STATION HILL

READING

AMENDMENTS TO RMA REF:
190465 PLOT E

NOV 2019

Plot E - Lower Ground
Floor Level (39 AOD)

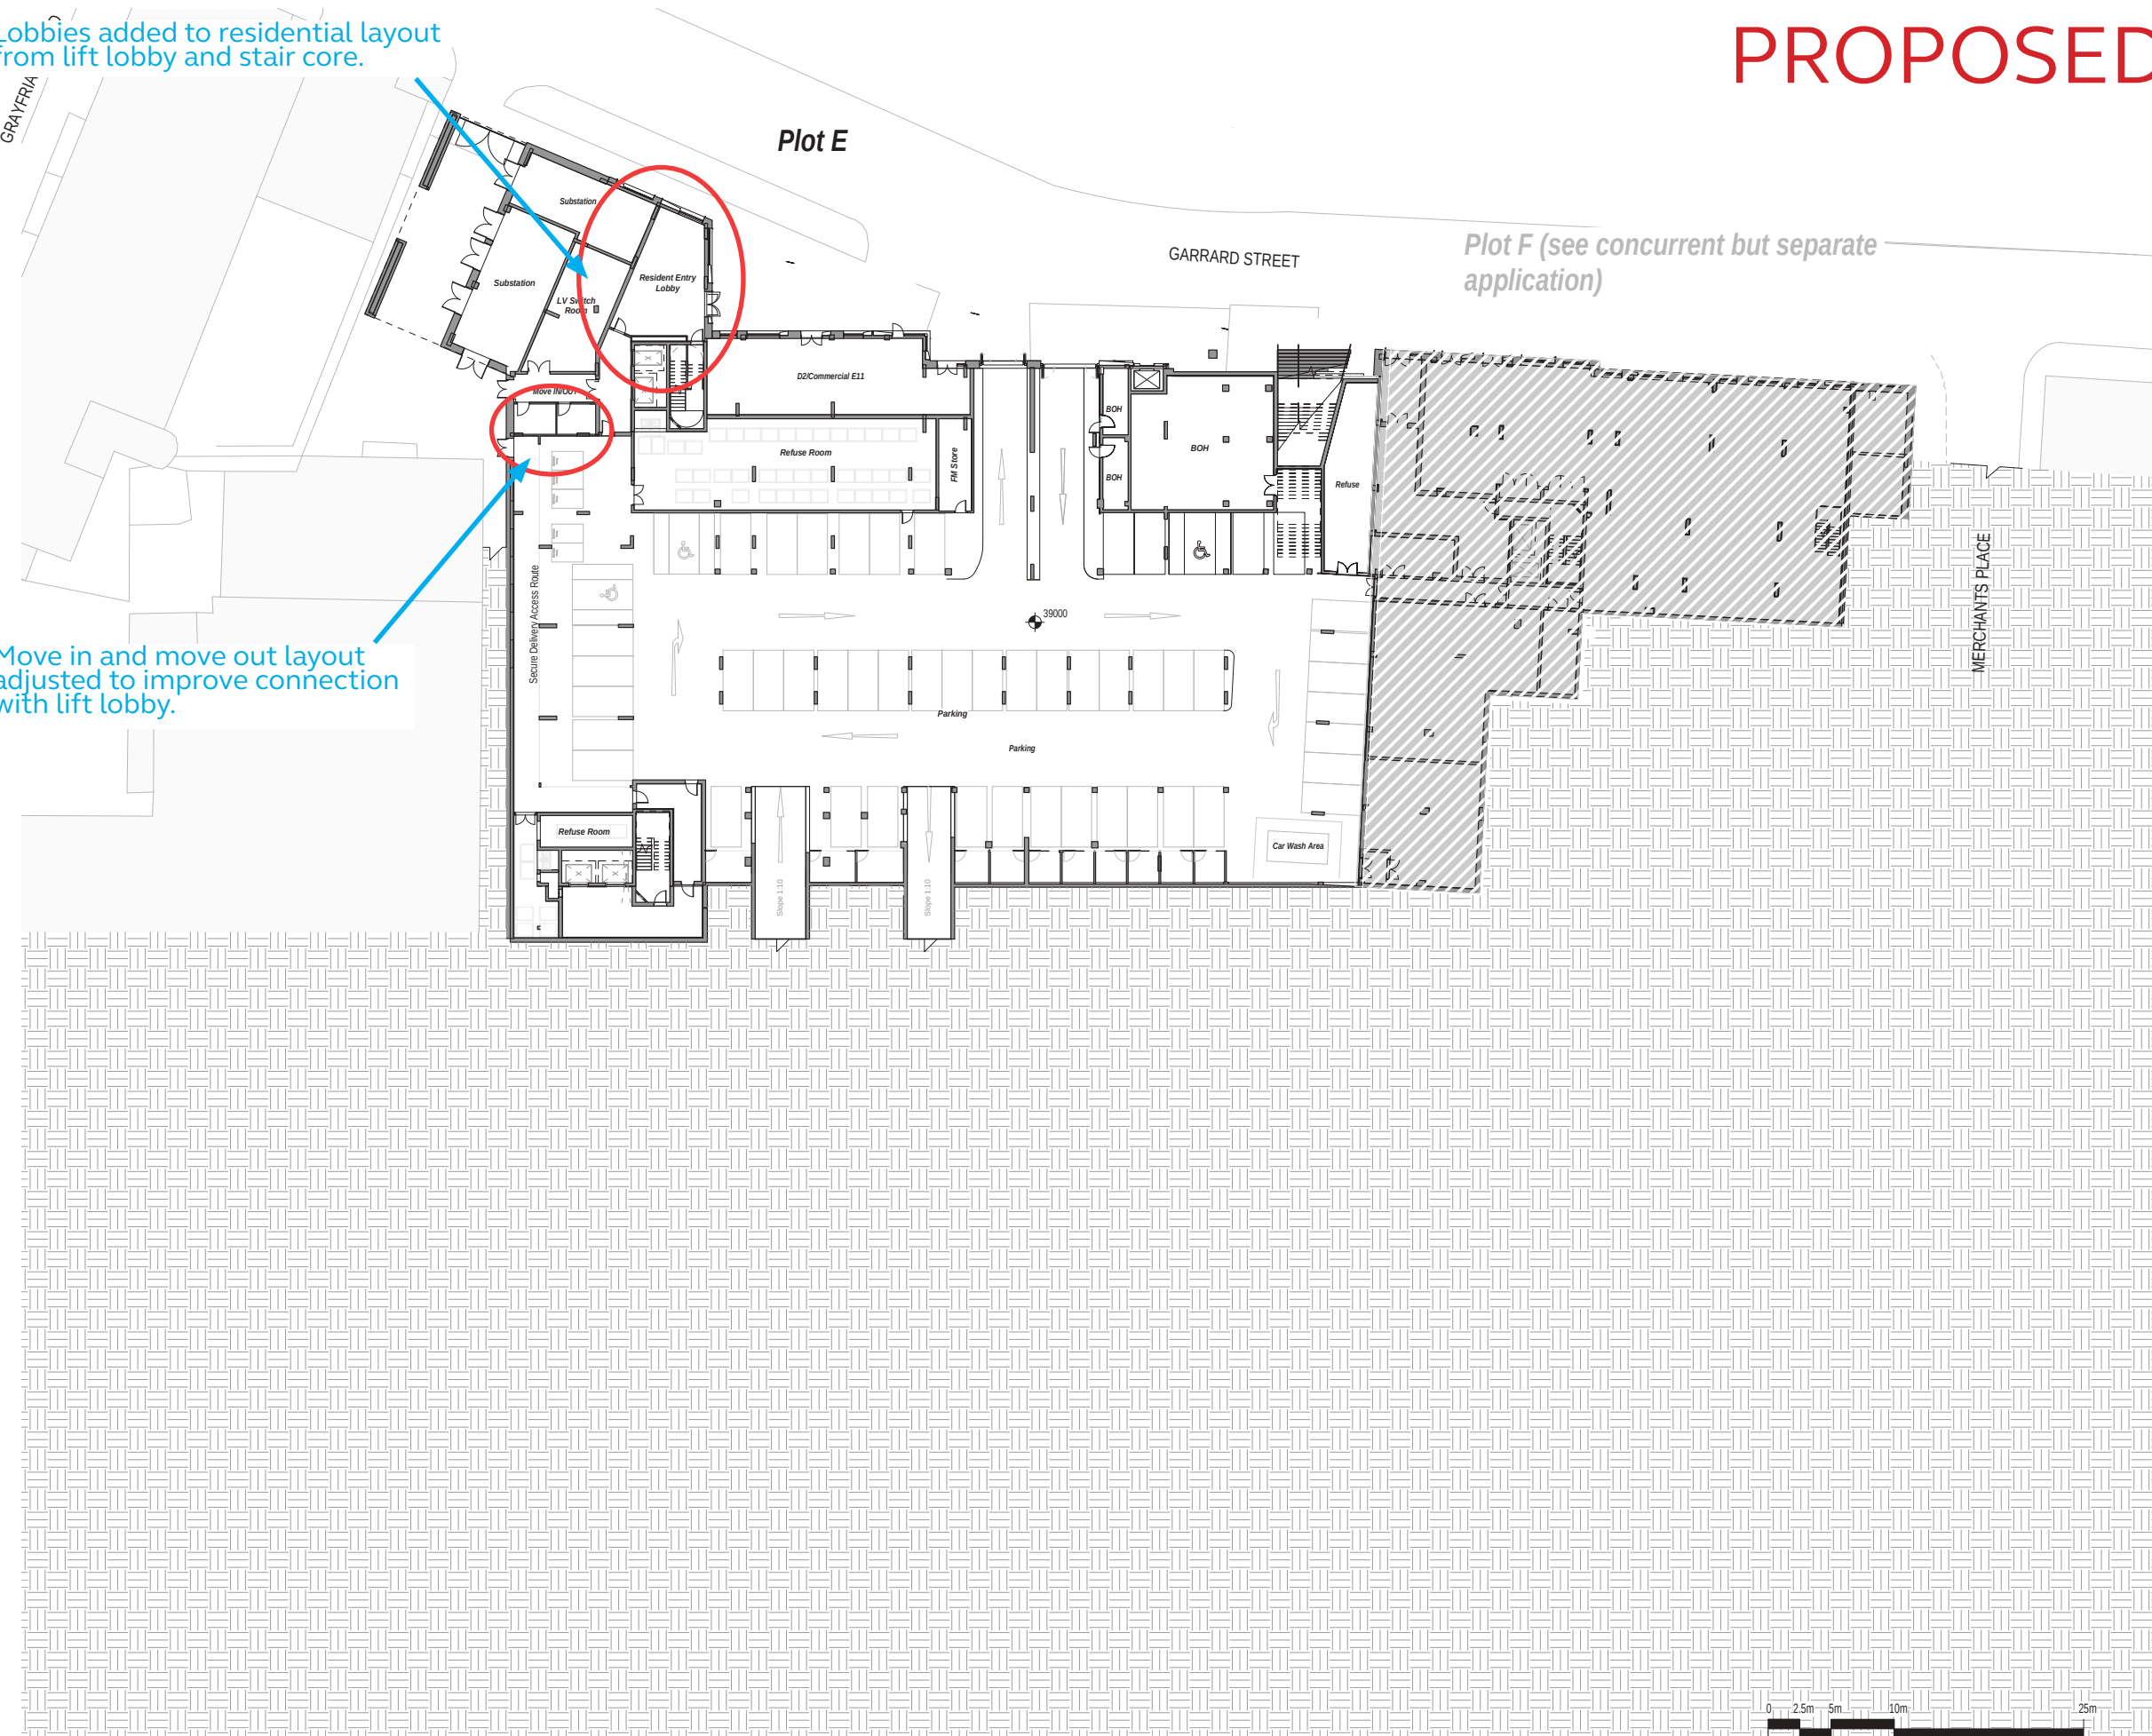
Lobbies added to residential layout from lift lobby and stair core.

Move in and move out layout adjusted to improve connection with lift lobby.

TITLE
Plot E - Mezzanine Floor
Level (41.3 - 42.1 AOD)

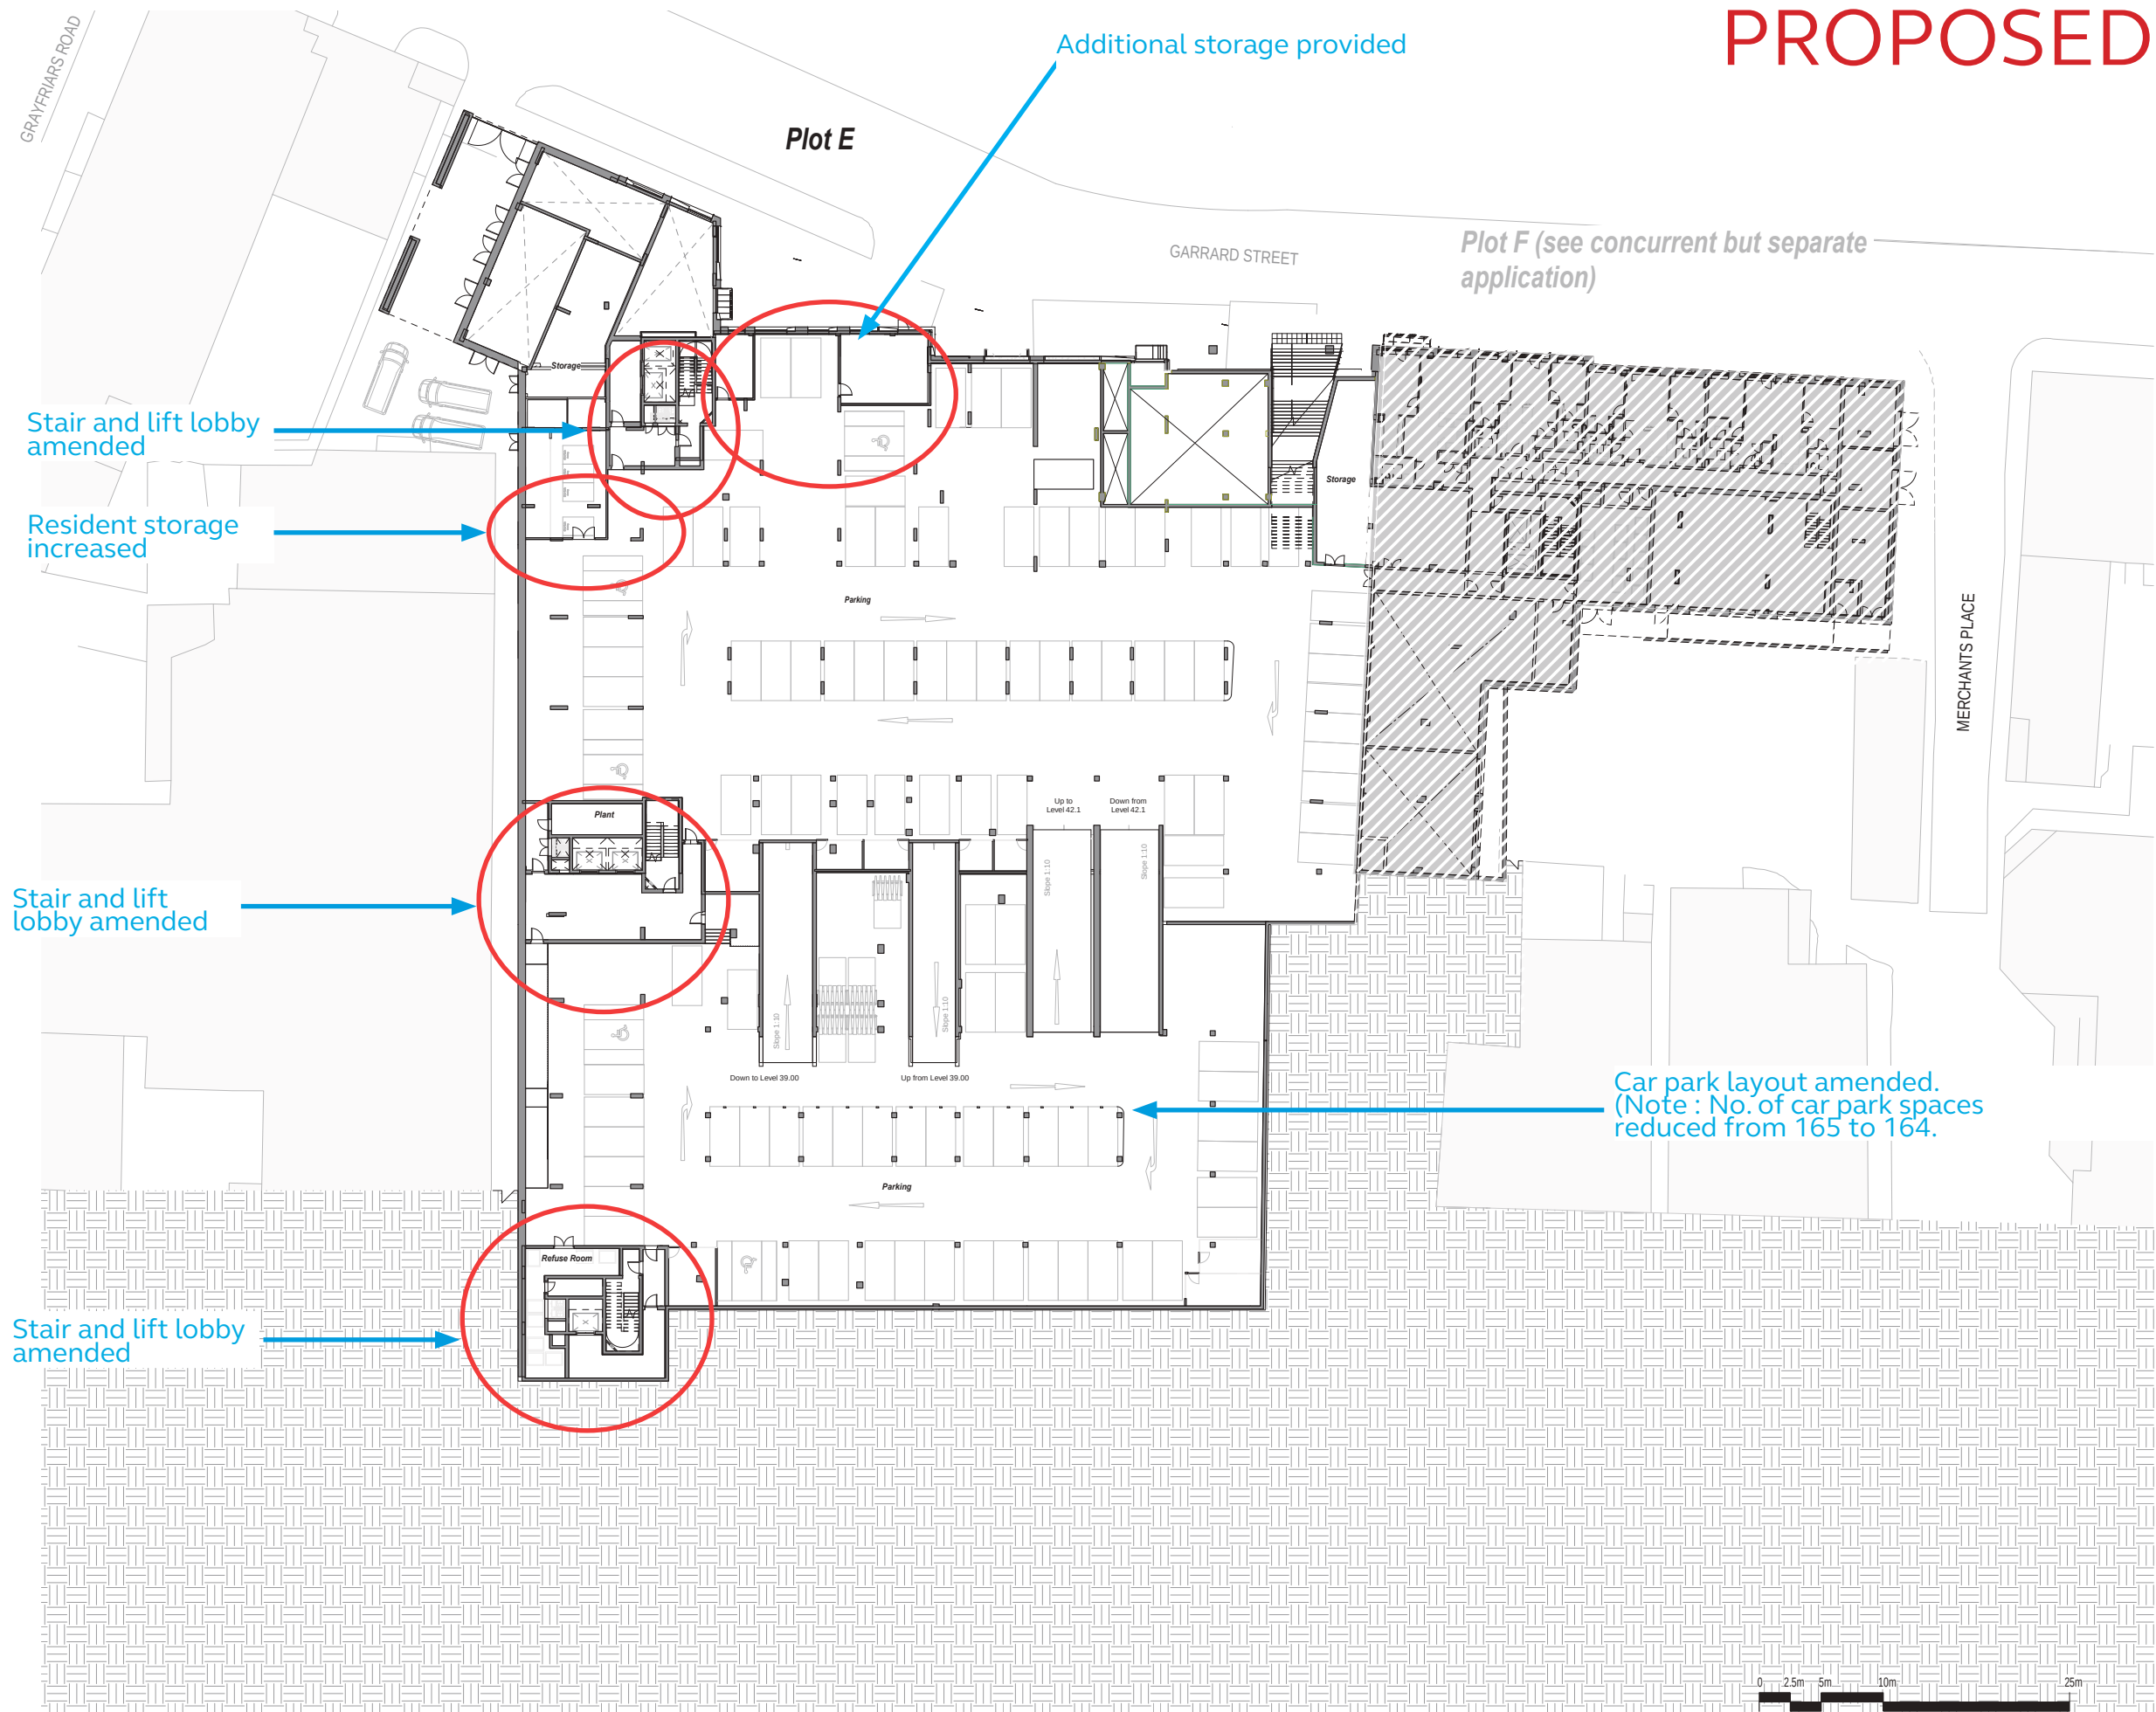
At mezzanine level additional management storage rooms have been provided and internal adjustments to improve access to the stair cores.

**Site - Friar Street
Elevation Plot E**

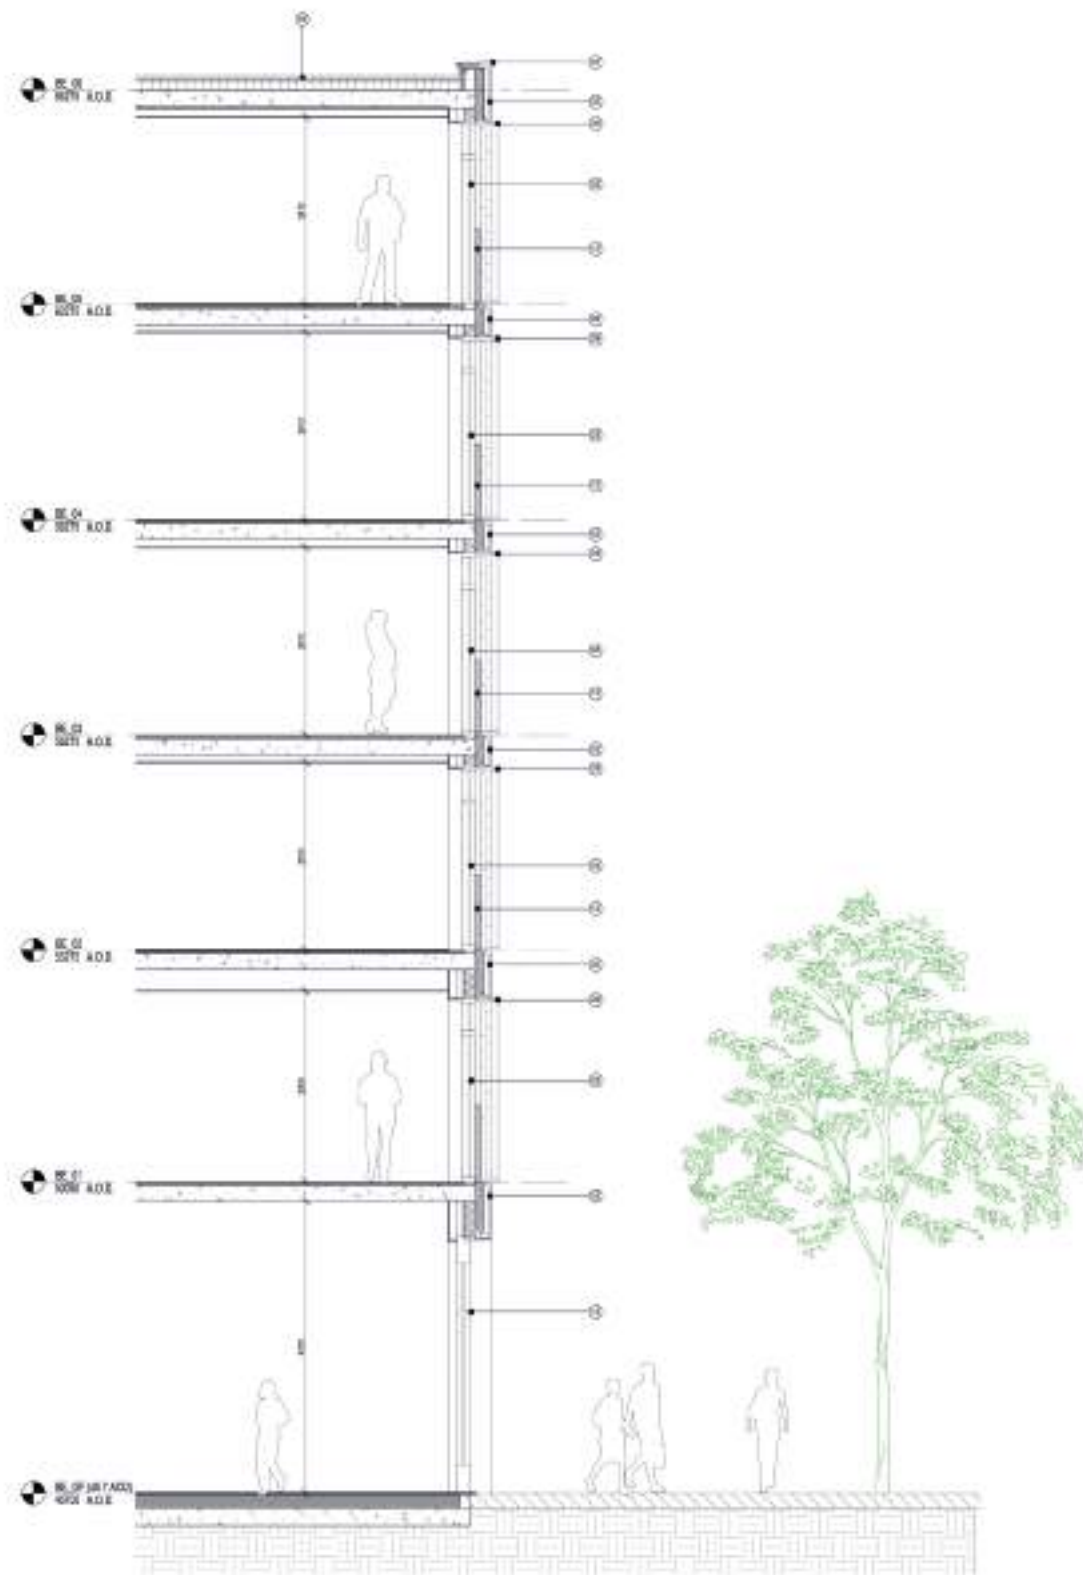
Soldier course band reduced to fit between windows

1 Plot E - Friar Street - Brick - Bay Elevation
1:50

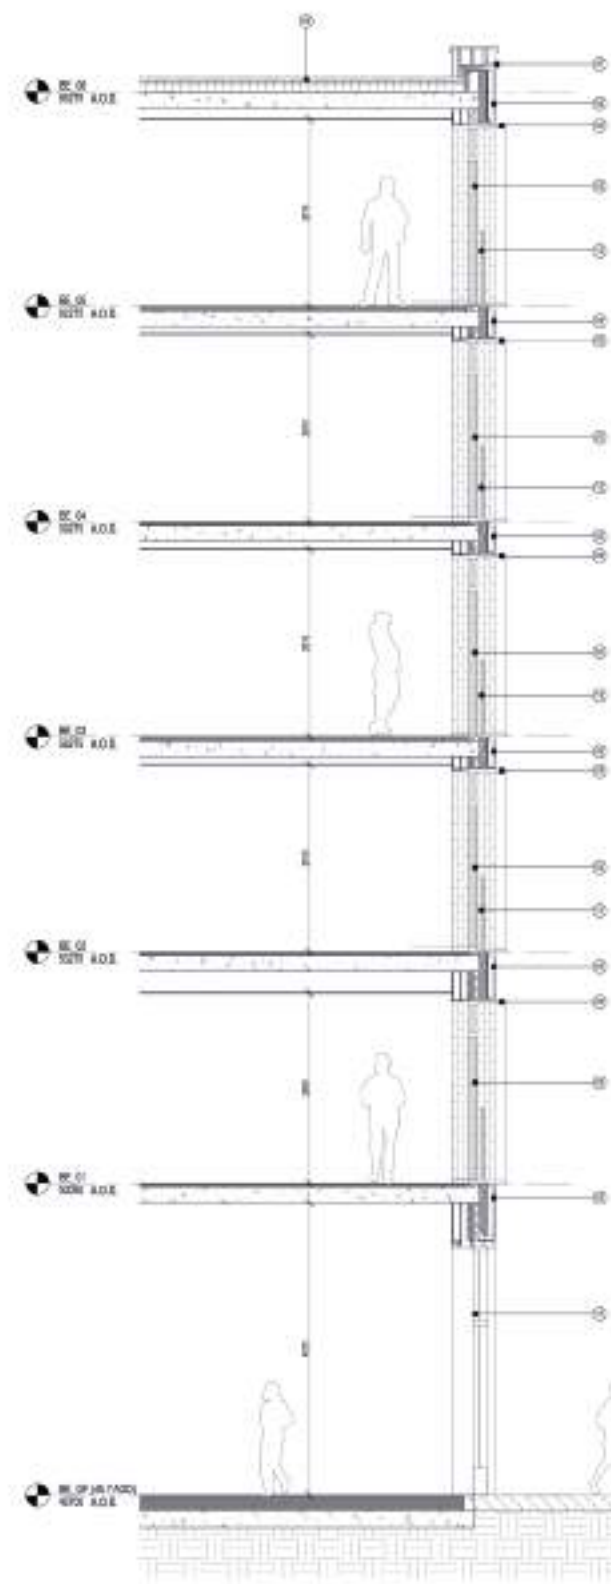
Glass balustrades replaced with metal railings across all façades

Soldier course band reduced to fit between windows

Soldier course band reduced to fit between windows (tree removed for clarity).

1 Plot E - Friar Street - Brick/ Lantern - Bay Elevation
1:50

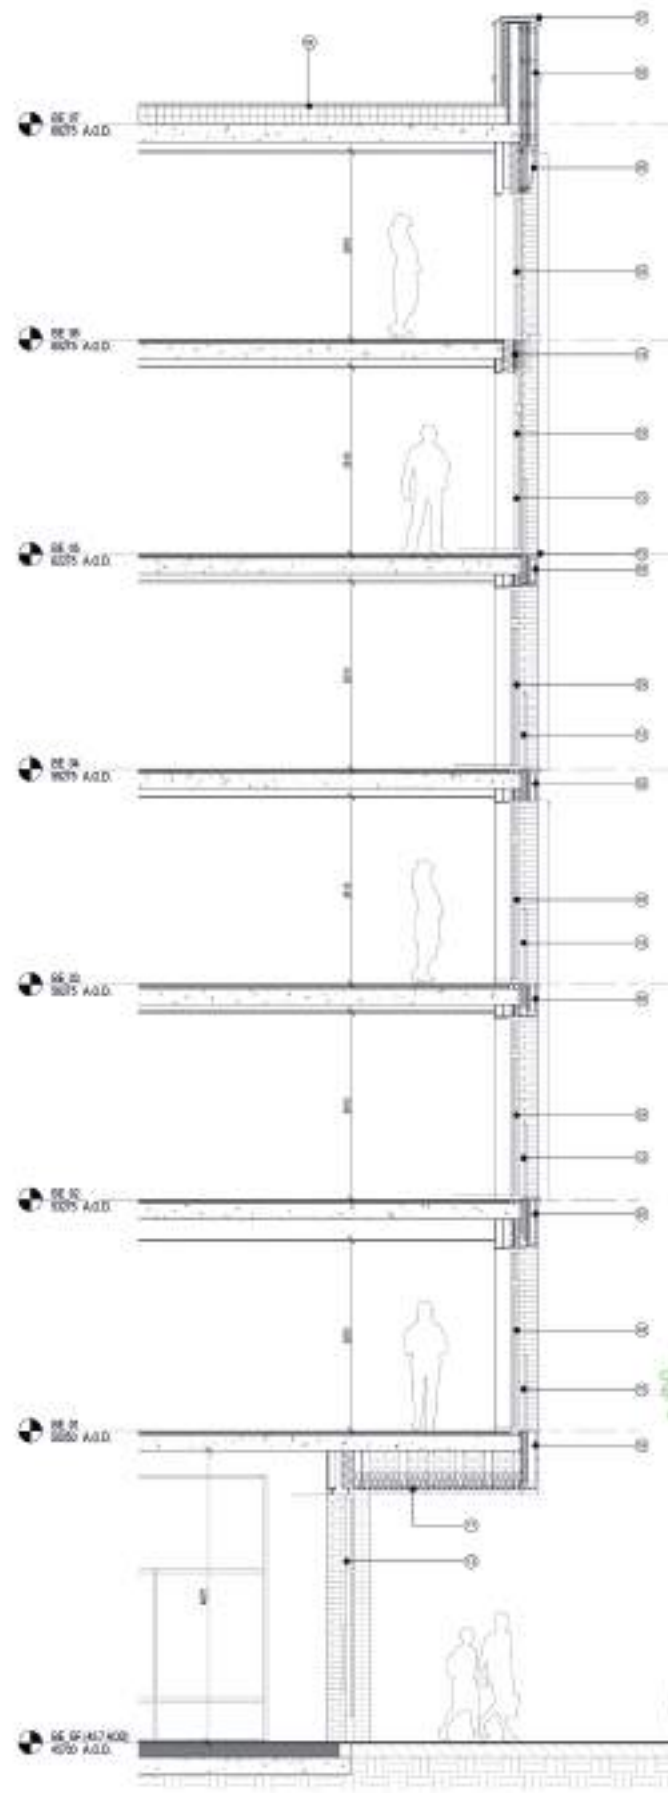
Glass balustrades replaced with metal railings across all façades

Soldier course band reduced to fit between windows

Soldier course band reduced to fit between windows (tree removed for clarity).
